Roundabout Design Report

Re: Lorson Ranch East
Roundabout Report
El Paso County, CO
LSC #164360

Figure 6

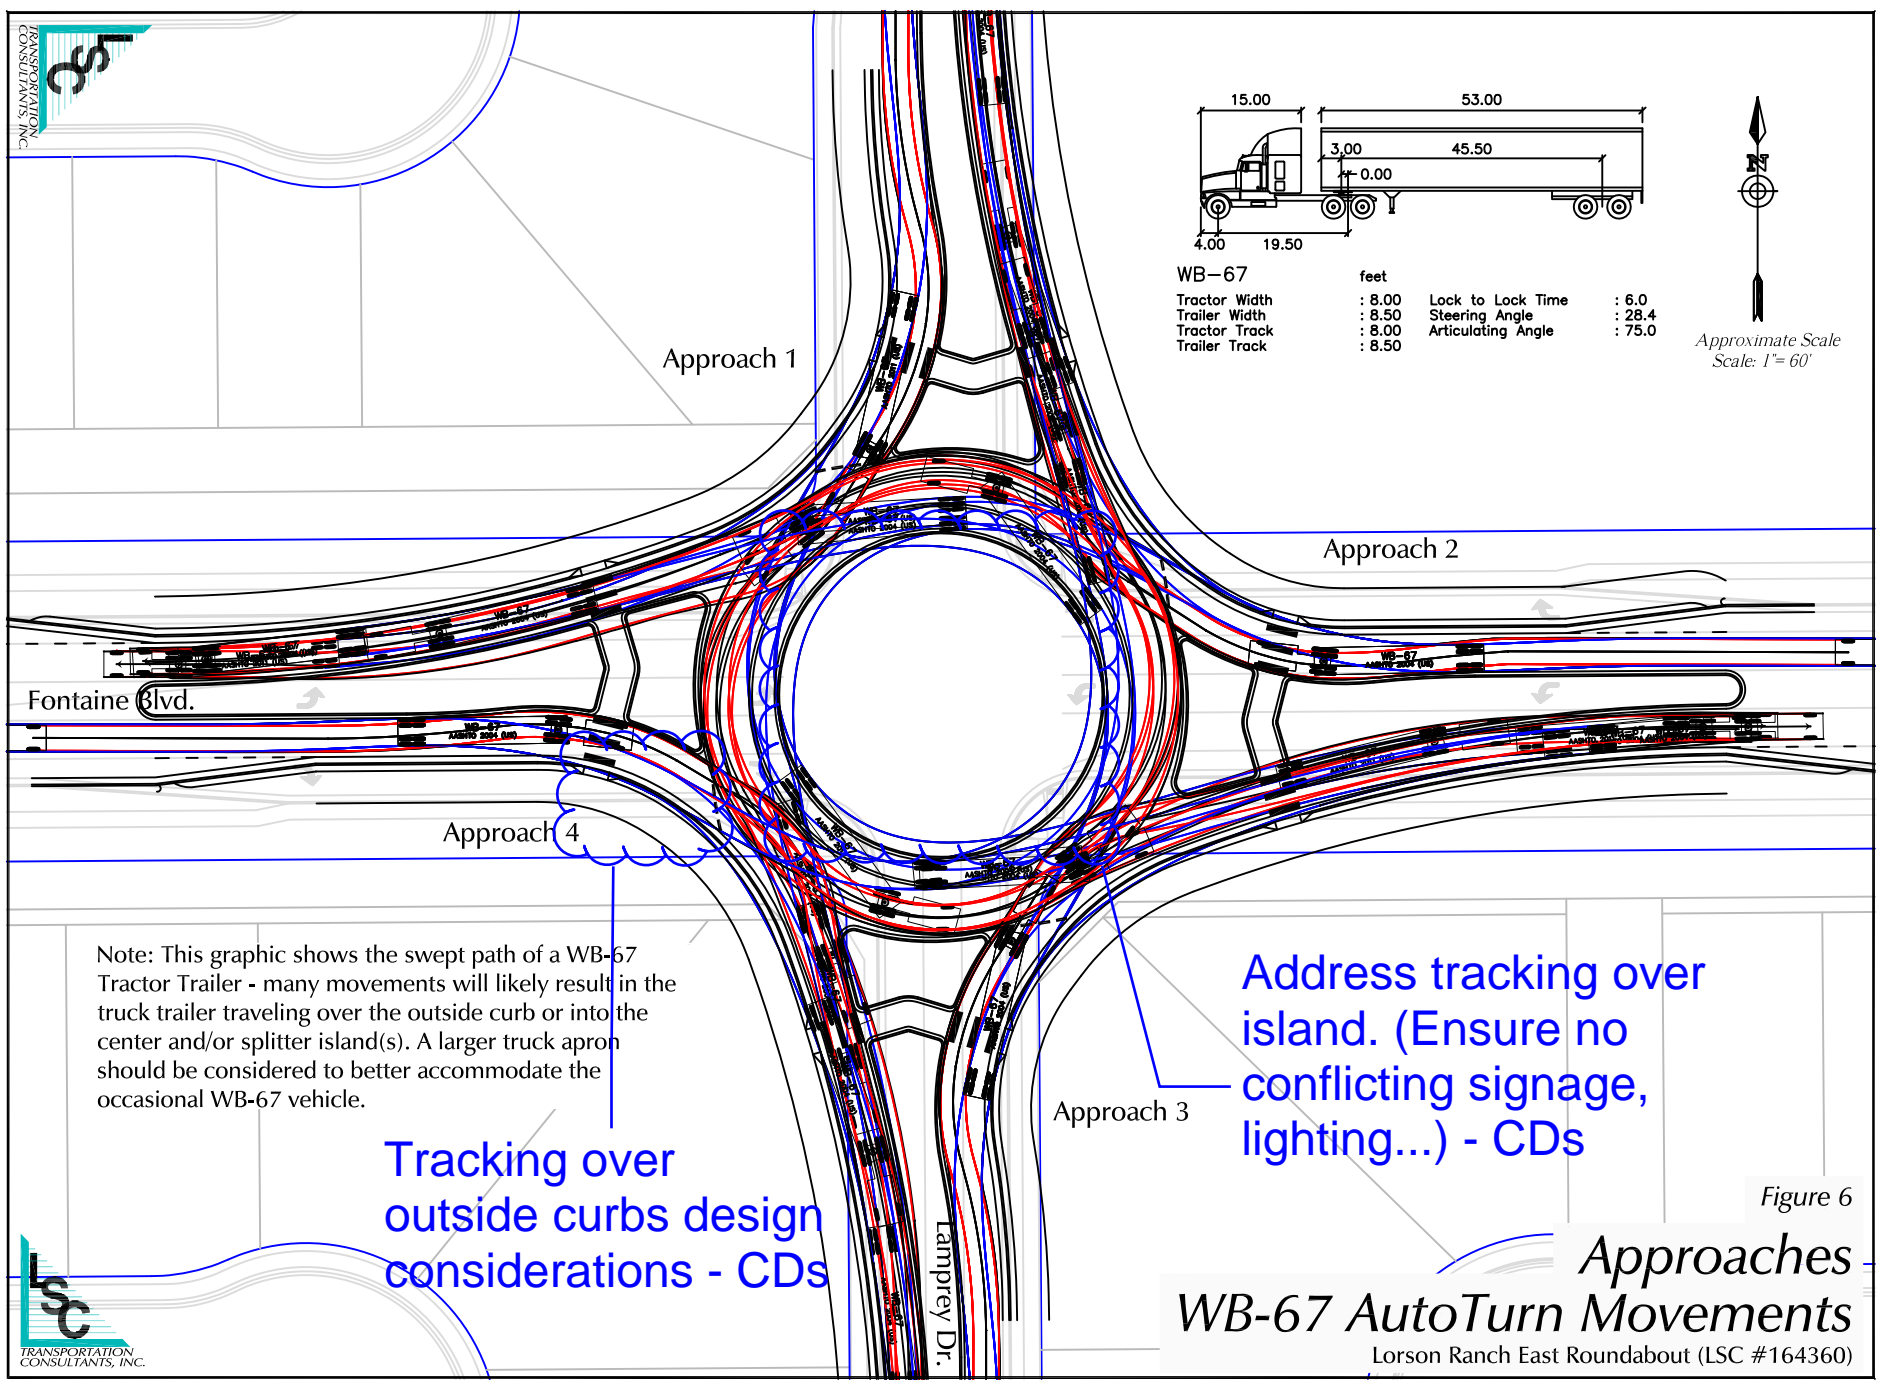
Tracking over outside curbs design considerations - CDs

Address tracking over island. (Ensure no conflicting signage, lighting...) - CDs

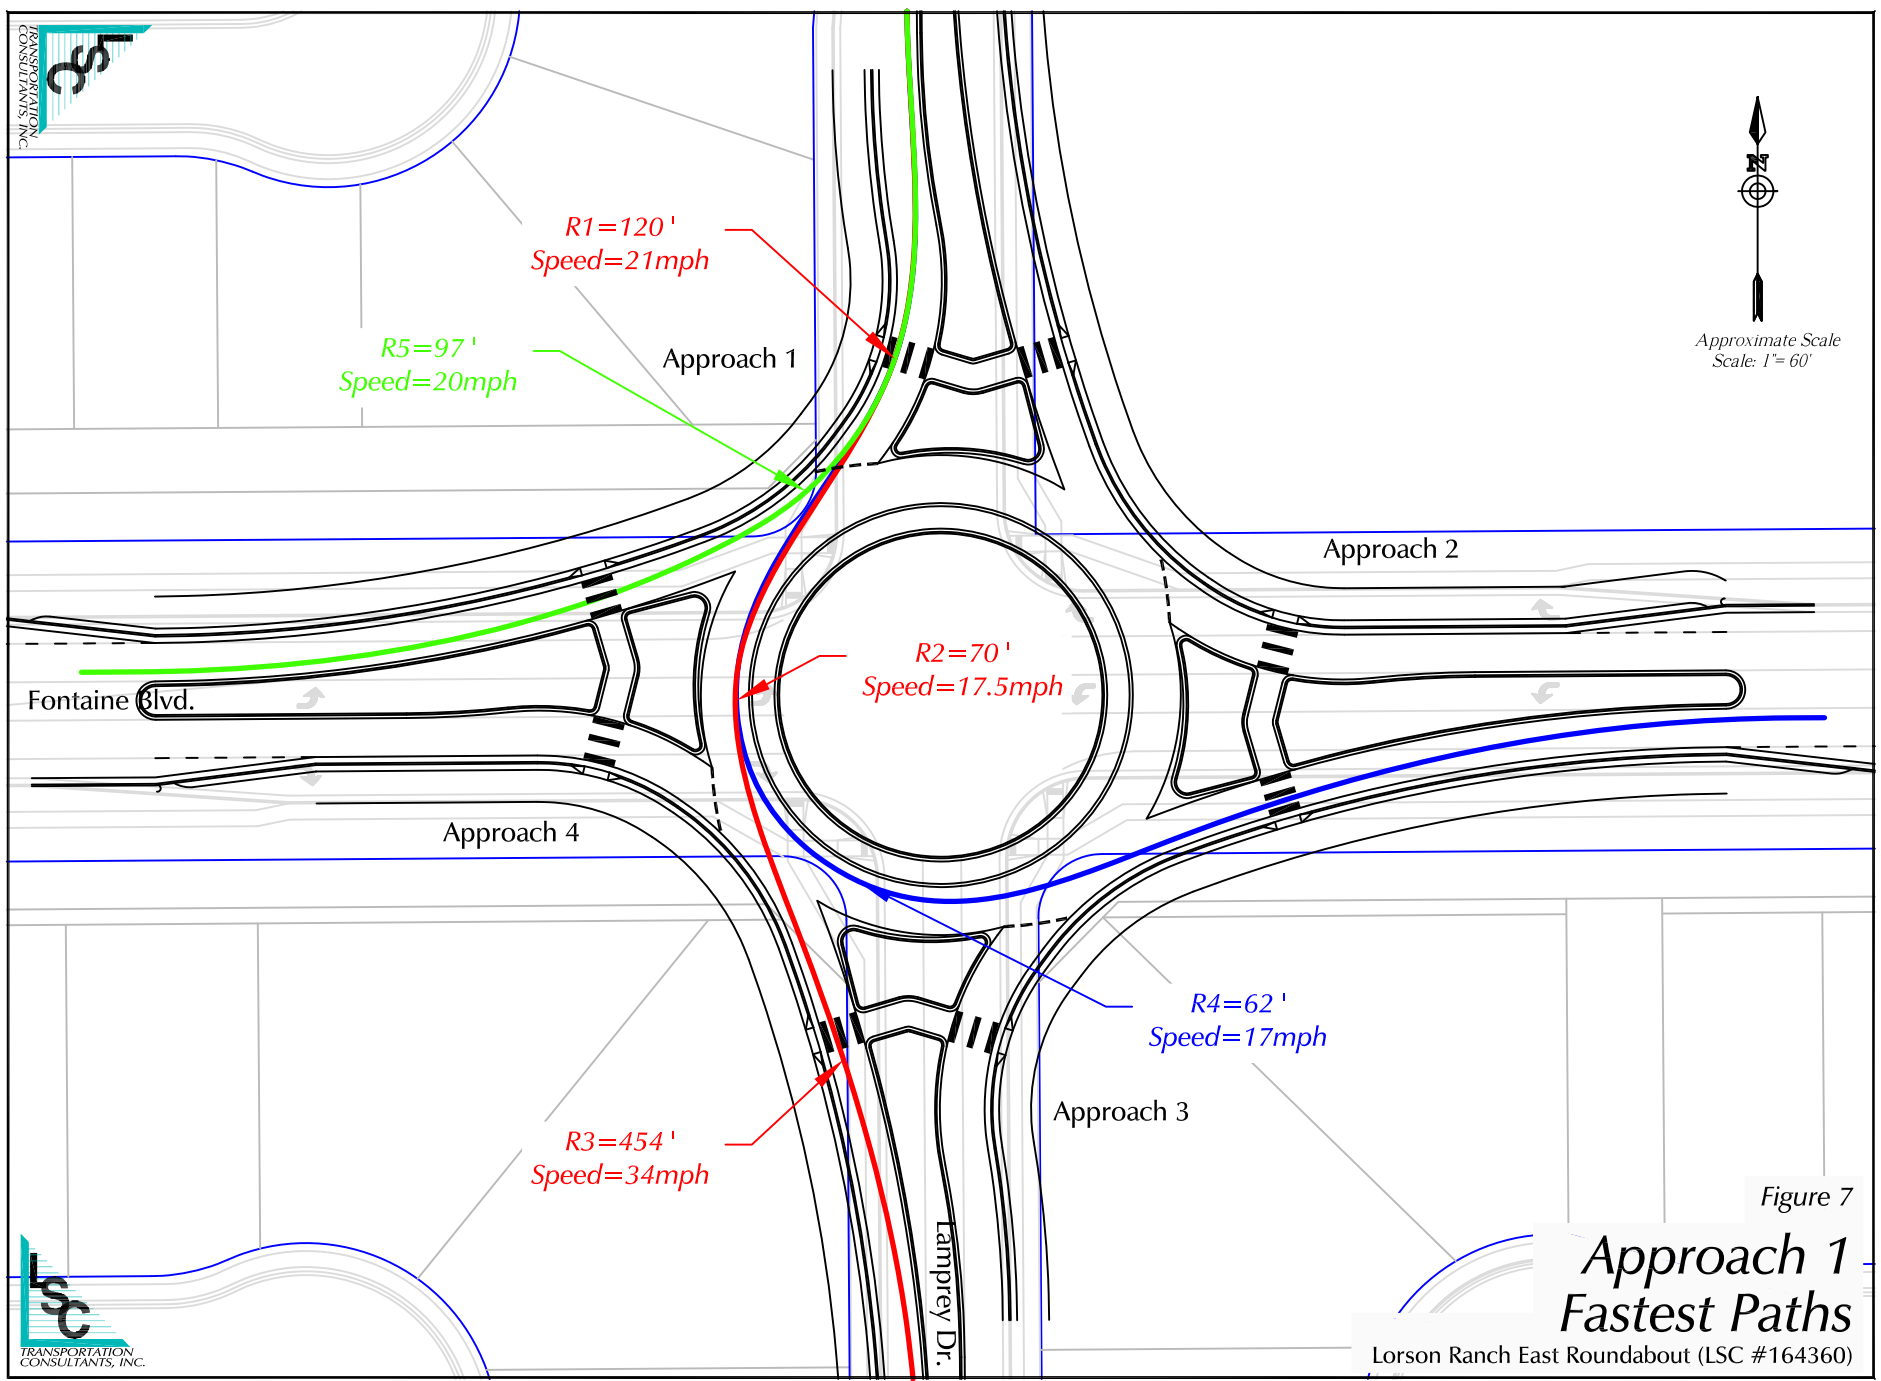
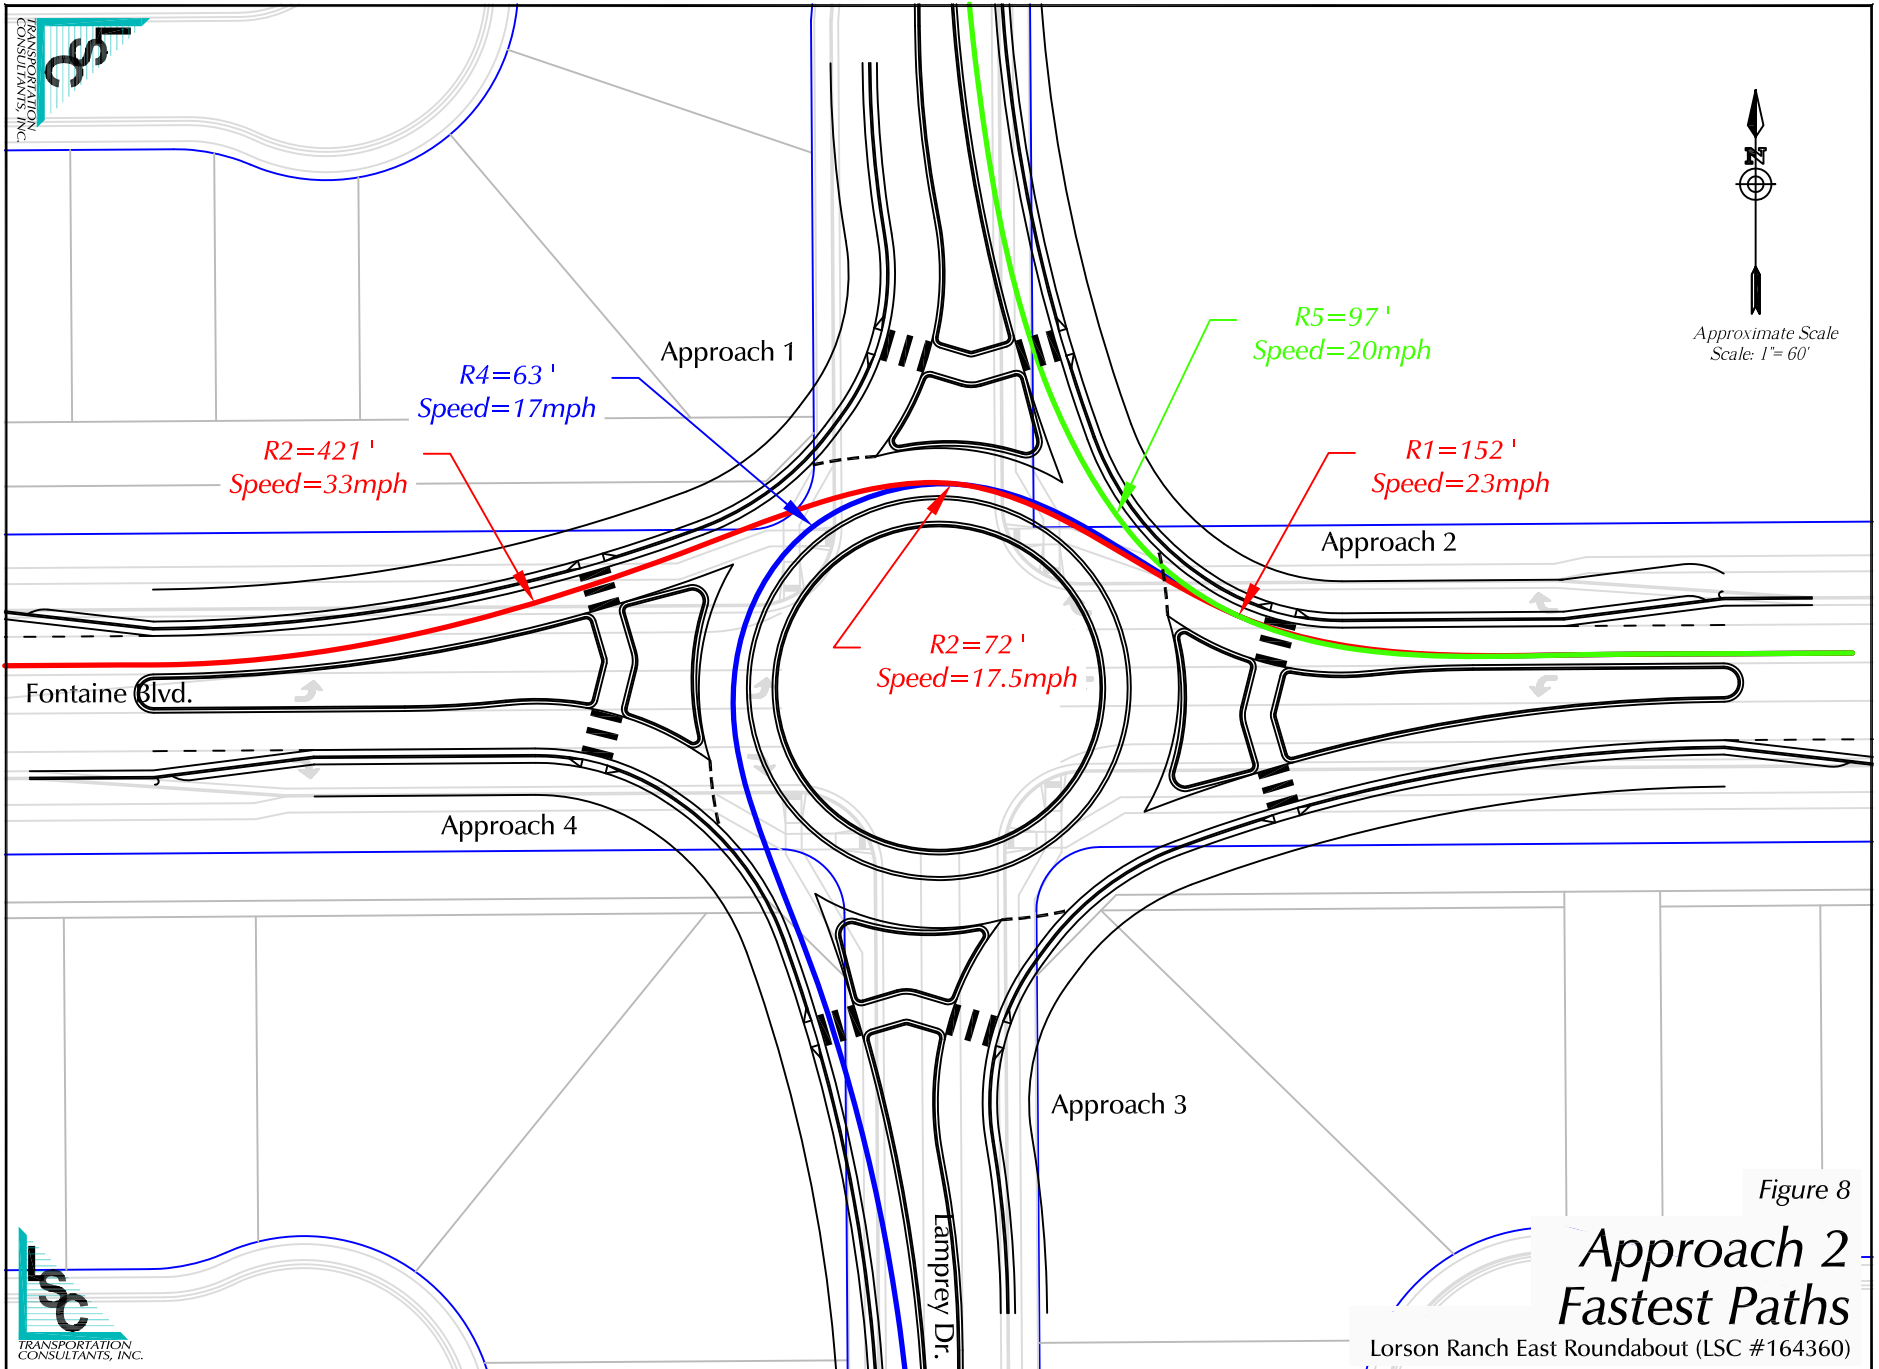
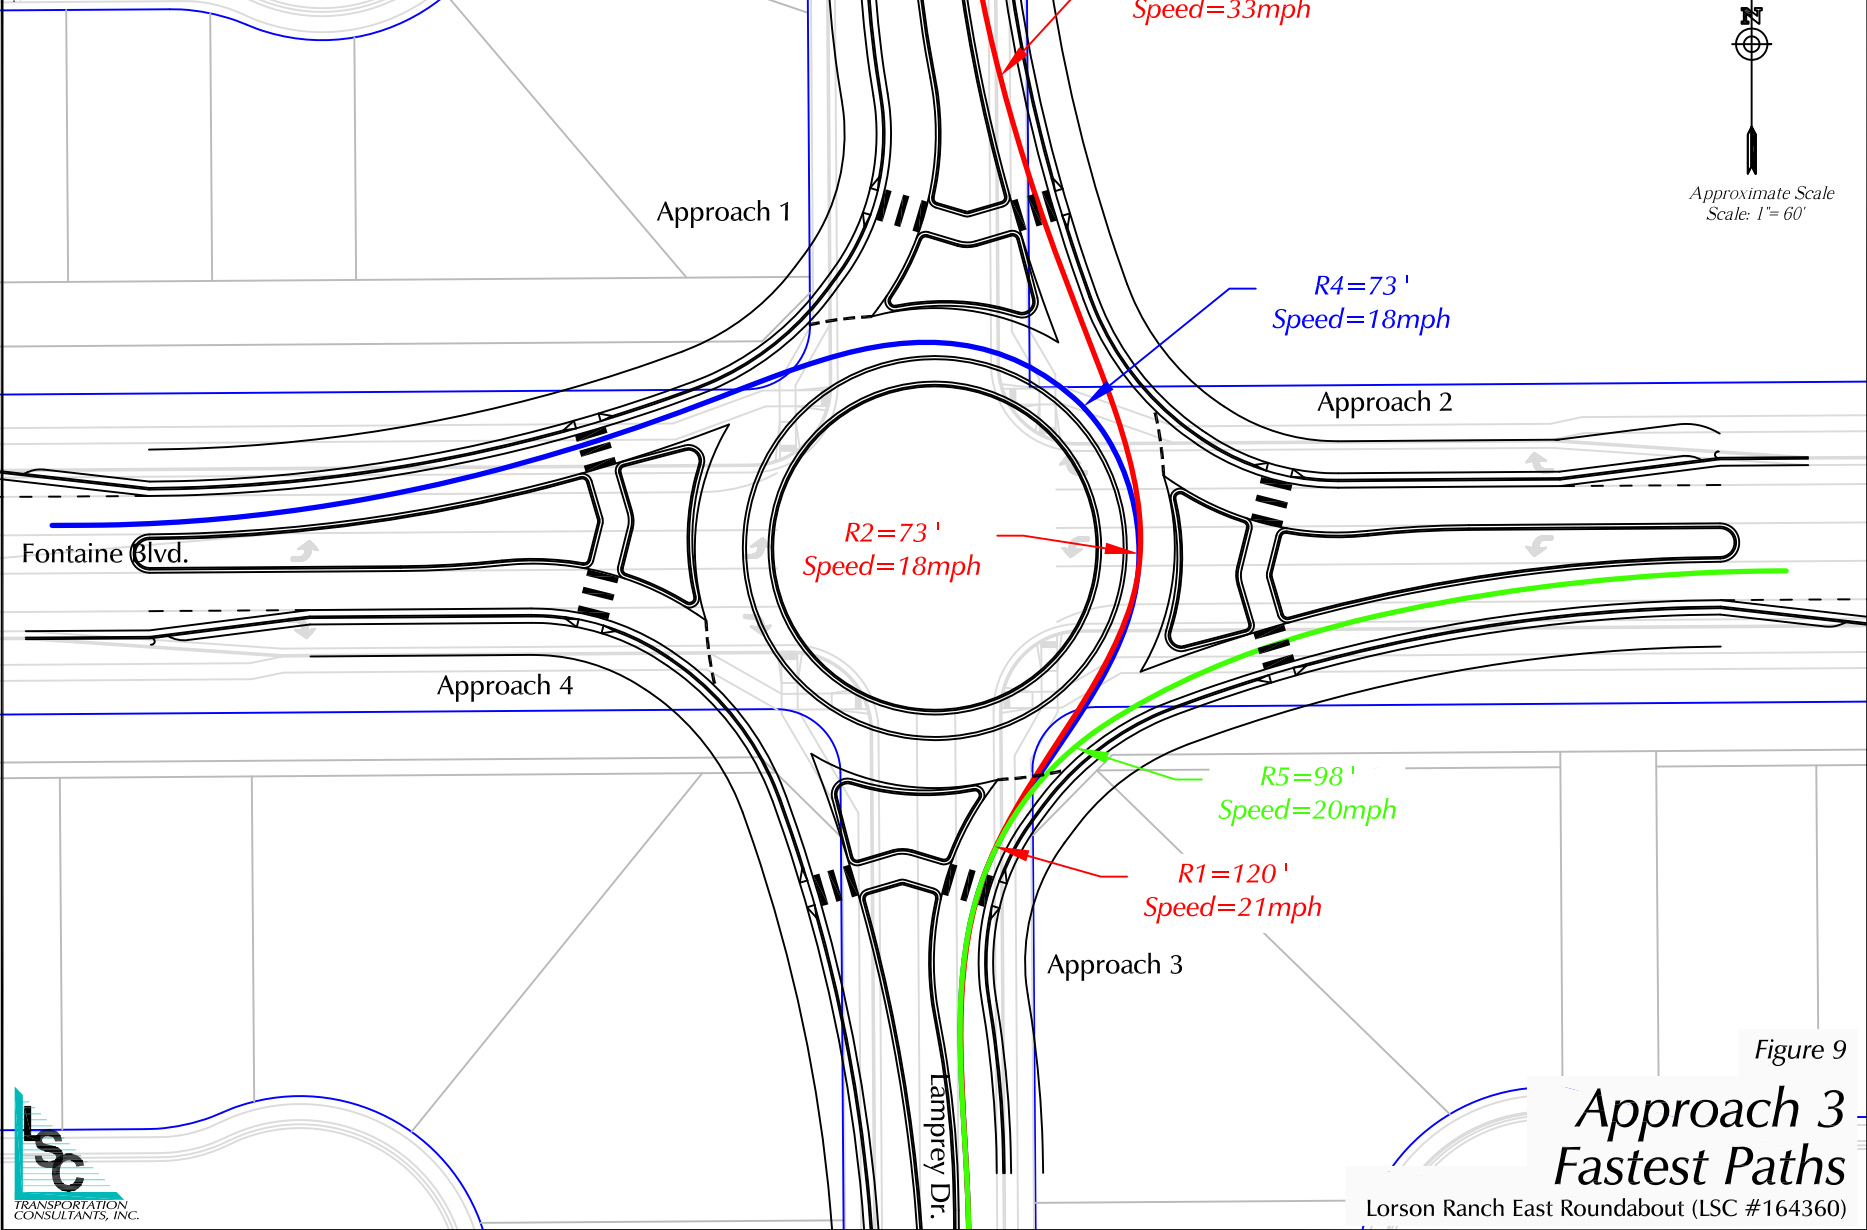
Has it been revised?

15.5 and 17 per FDM 30.5.23
